## Urgent Field Safety Notice

Applicable to REPLY, ESPRIT, KORA and FACIL<sup>1</sup> pacemakers  
manufactured by Sorin Group Italia S.r.l.

## Improved residual longevity displayed by the programmer

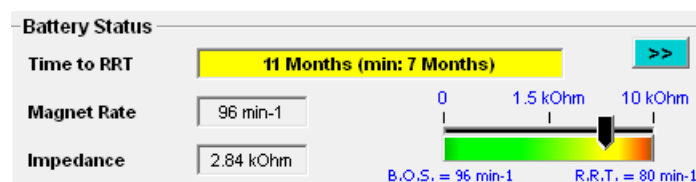
- If the **typical and minimal estimated time to RRT** are **between 3 months and 3 years**, the “*typical time to RRT in years and months (Minimal time to RRT)*” are displayed and:
  - the corresponding text field background is grey, if the **minimal estimated time to RRT** is **>12 months**;

- The corresponding text field background is yellow, if the **minimal estimated time to RRT** is **≤12 months**. A Warning will be displayed “*In the current conditions of use, the minimum residual longevity ≤ 12 months.*”

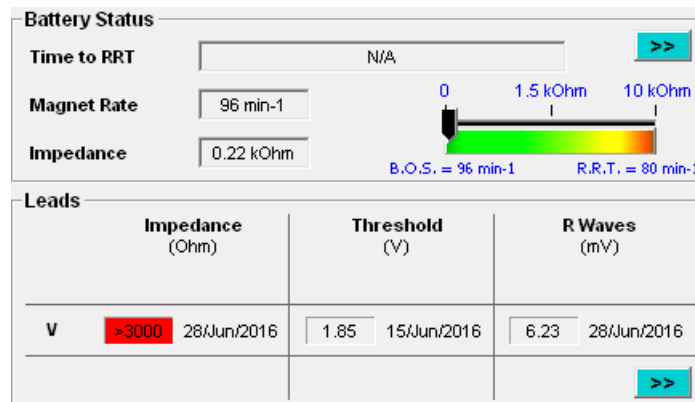
- If the **minimal estimated time to RRT** is **<3 months**, “< 3 months” is displayed and the corresponding text field background is orange. A Warning will be displayed: “*In the current conditions of use, the minimum residual longevity ≤ 3 months.*”

- If the **RRT has been reached**, “RRT has been reached” is displayed and the corresponding text field background is red.
